HISTORIC AND DESIGN REVIEW COMMISSION

September 16, 2015

HDRC CASE NO: 2015-356
ADDRESS: 606 N PRESA ST
LEGAL DESCRIPTION: NCB 416 BLK 23 LOT E IRRG 60.9 FT OF W 100.9 FT OF 5 OR ARB A6
ZONING: D H HS RIO-3
CITY COUNCIL DIST.: 1
DISTRICT: Alamo Plaza Historic District
LANDMARK: Maverick, George Building
APPLICANT: Anna Hudson
OWNER: 400 E Houston, LP
TYPE OF WORK: Rehabilitation with Tax Certification
REQUEST:

The applicant is requesting a Certificate of Appropriateness for approval to rehabilitate the structure at 606 N Presa and receive Historic Tax Certification.

FLOOR PLAN -
PENTHOUSE

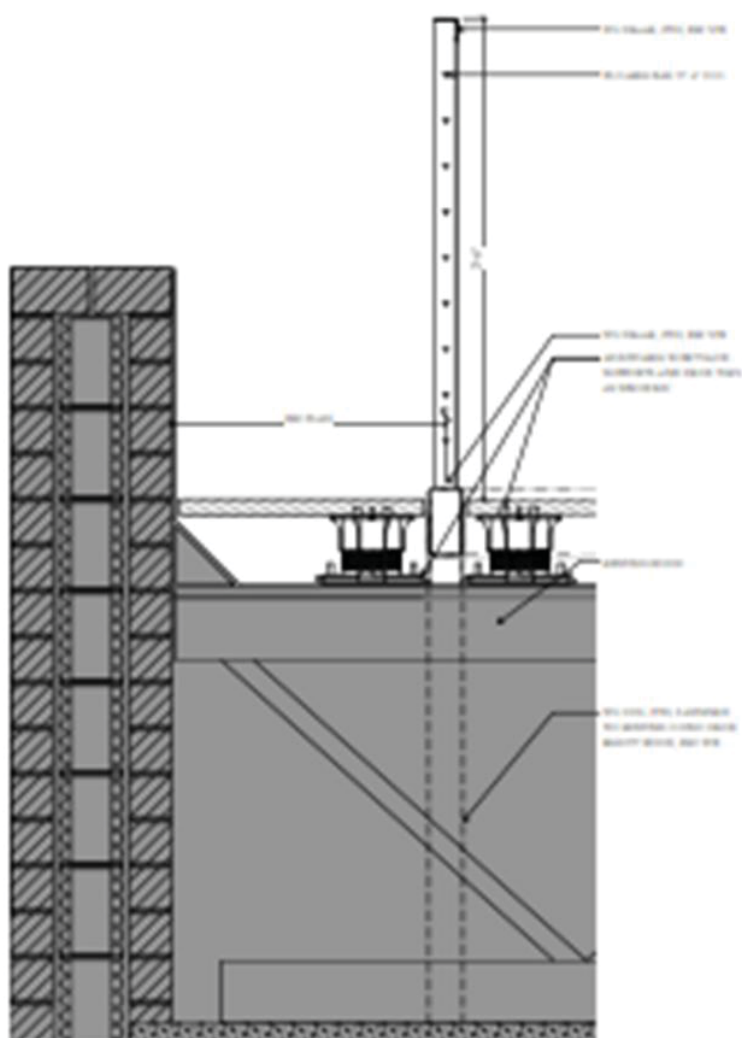
- f. At the roof, the applicant has noted that the existing penthouse space currently is not usable. The applicant has proposed to install an emergency exit to the north elevation along with a metal fire scape type stair and solid door to the right of the existing windows. On the south elevation, an additional window will be added to match those of the north elevation. While the applicant has proposed to create new window and door openings not original to the structure, staff finds that the proposed window and door's locations, not visible from the public right of way are appropriate as well as necessary to make the existing space habitable.

- g. At the southwest corner of the roof, the applicant has proposed to construct a wood patio to be setback approximately 3' – 2" from the parapet wall. The applicant has proposed a guardrail consisting of a steel frame with metal cables

along the south elevation and return at the southwest corner. The applicant has noted that the guardrail will be setback from the roof's edge and given the height of the existing parapet and proposed setback, will not be visible from the public right of way.

Staff recommends approval as submitted based on findings a through g.
